Docket No. 50-336  
B11549

Millstone Nuclear Power Station, Unit No. 2  
Proposed Revisions to Technical Specifications

Spent Fuel Rerack Safety Analysis Report

Questions Identified by NRC  
Staff During May 17, 1984  
Bethesda Meeting

FIGURE 4-6  
Poison Box Section Detail

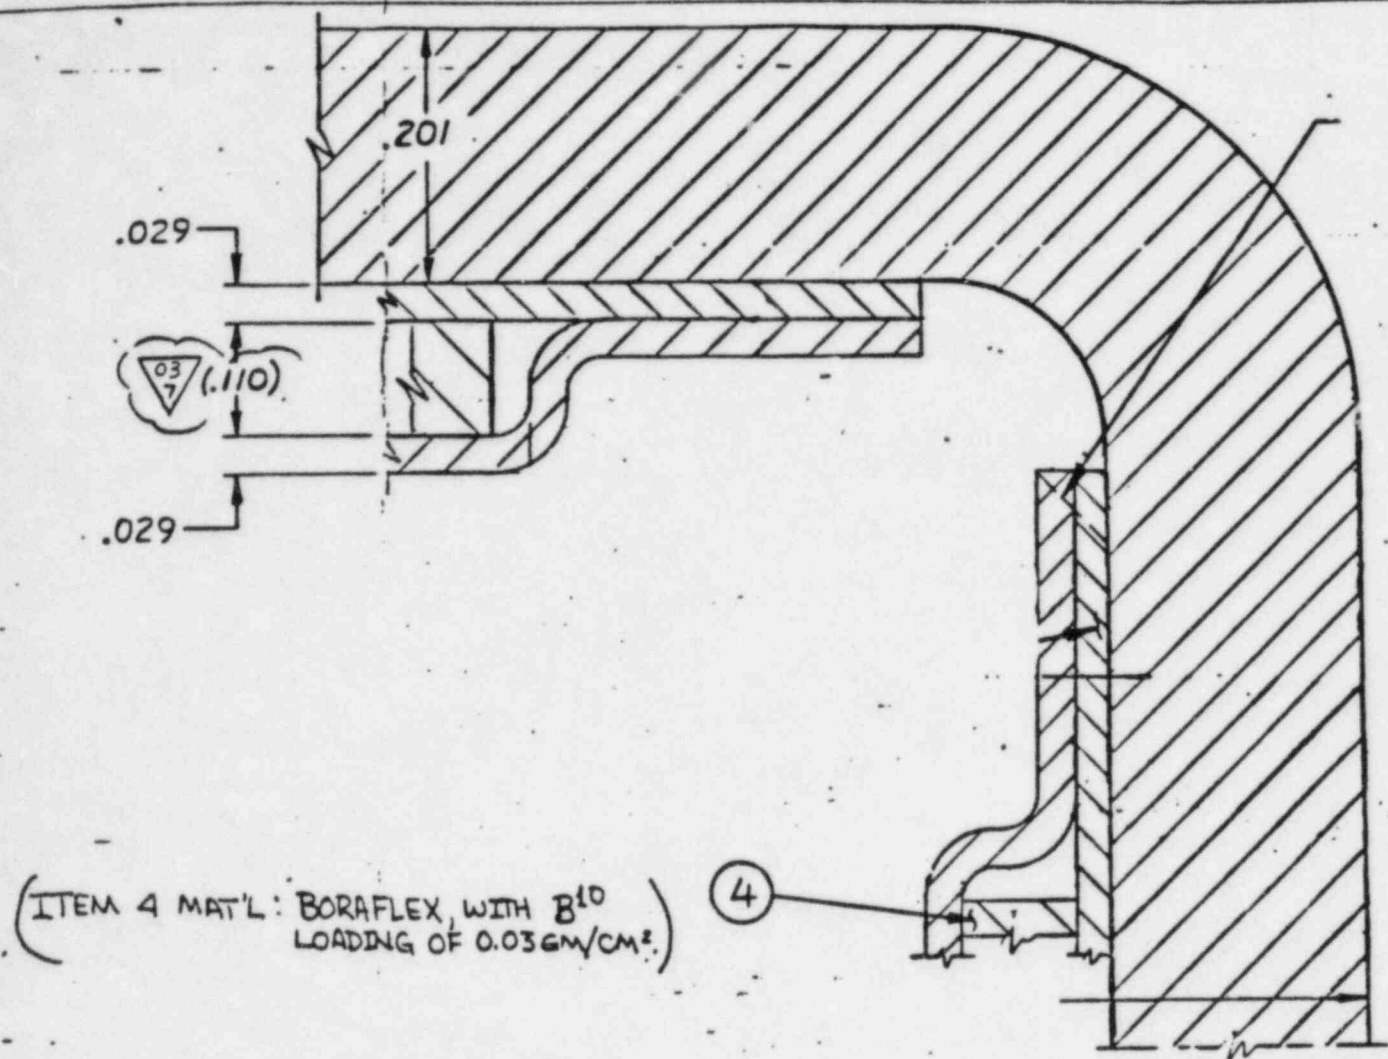
- o Provide details on the thickness of material on either side of the Boraflex.

Figure 4-6 of the Attachment 2 provides a detail of the inner and outer walls of the poison box.
